Turkey Point

expansion project

Sufficiency Responses

Date: February 27, 2004
Project No.: 0337600-0105

Figure 15. Cooling Canal and Biscayne Bay Salinity

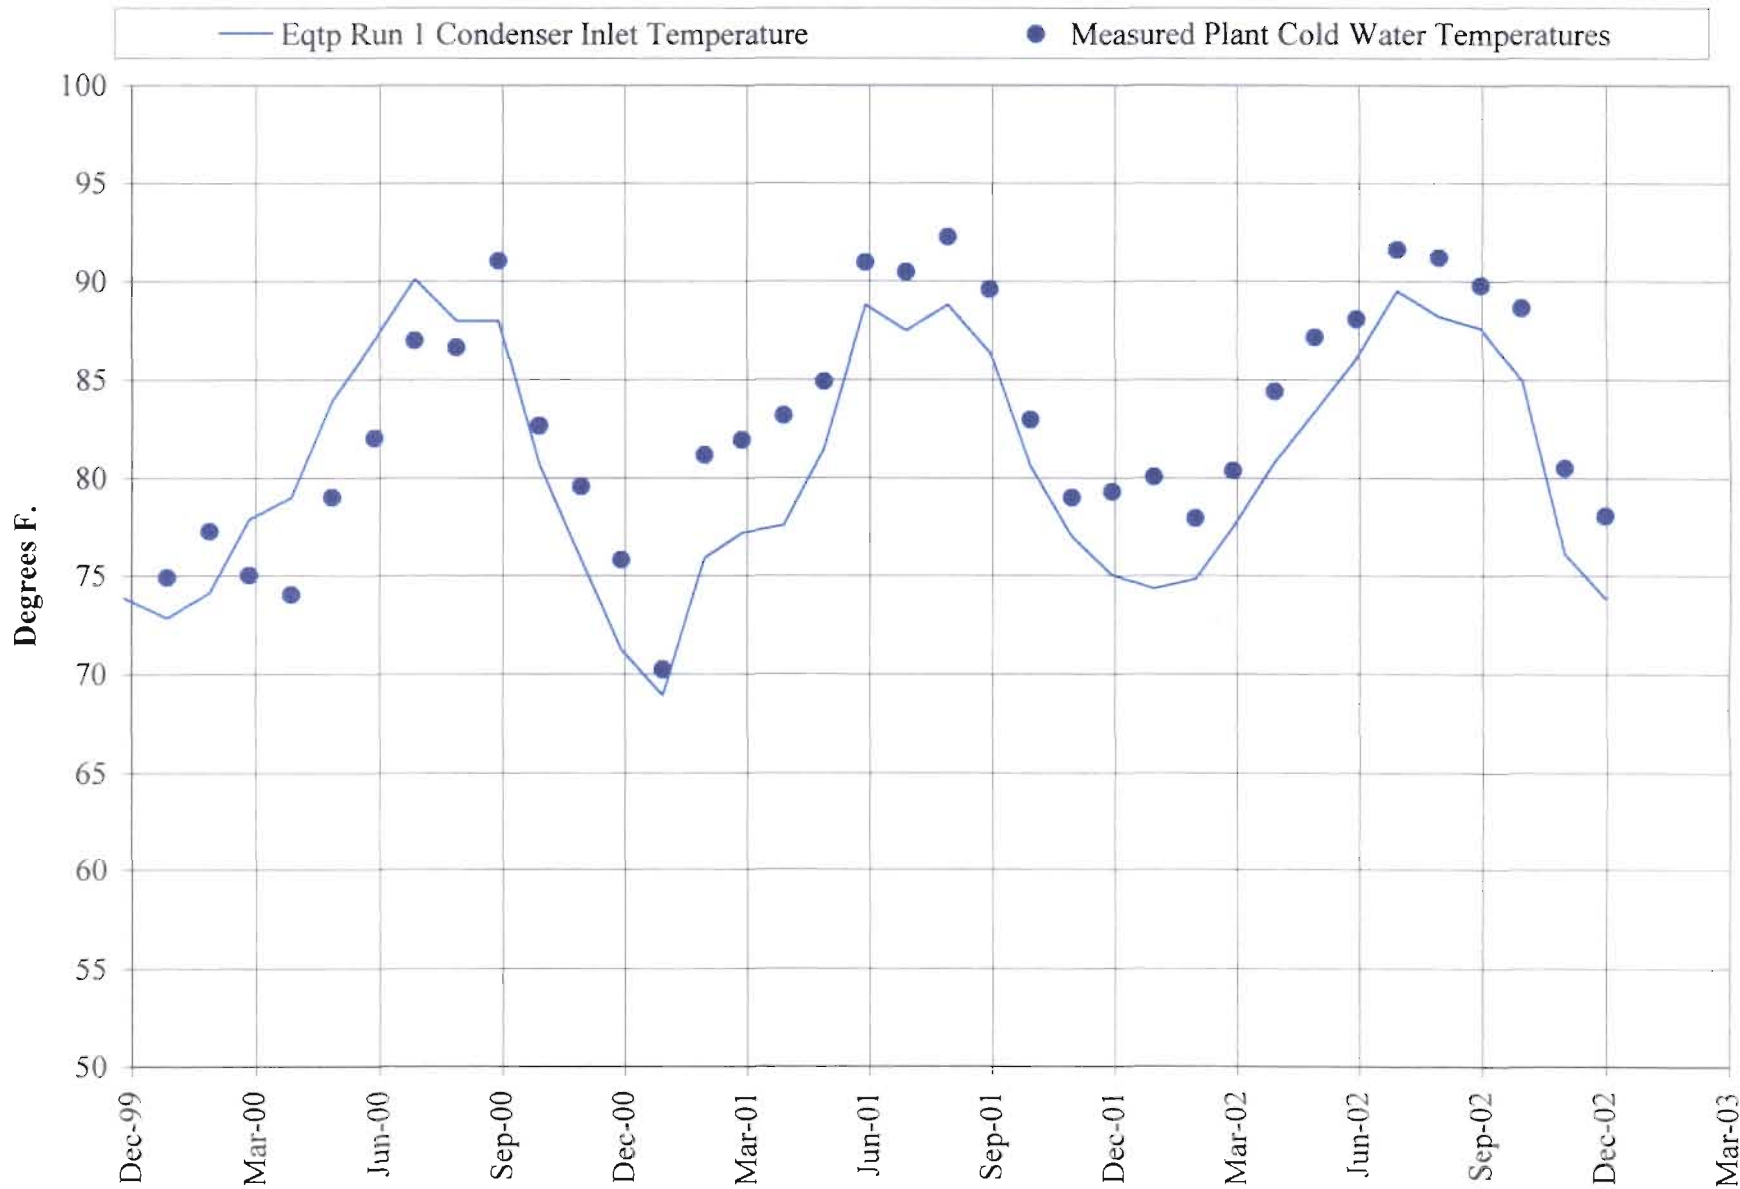
2FDEP Comment 4: Please reconcile the discrepancies in flow figures for the expansion among those presented in Figure 3.5-2 in Volume 1, and Figure 15 included in Appendix 10.7 "Cooling Pond Modeling Report" in Volume 3. It appears the latter might not have accounted for the R.O. concentrate and other process wastewater discharges involved.

Response 4: Appendix 10.7 has been updated to include all wastewater releases to the cooling canal system. The updated SCA Appendix 10.7 is attached as a replacement. The water use diagrams included in the SCA, which are Figures 2.3-8, 3.5-1, and 3.5-2, have also been updated and are attached as replacement pages. The R.O. waste stream of 56 GPM is accounted for with the other waste streams. The total waste stream is 4,746 GPM, while the R.O. waste stream is 1.2 percent of the total waste stream. Water from the Miami-Dade public water supply will be used as the water source for the demineralization process.
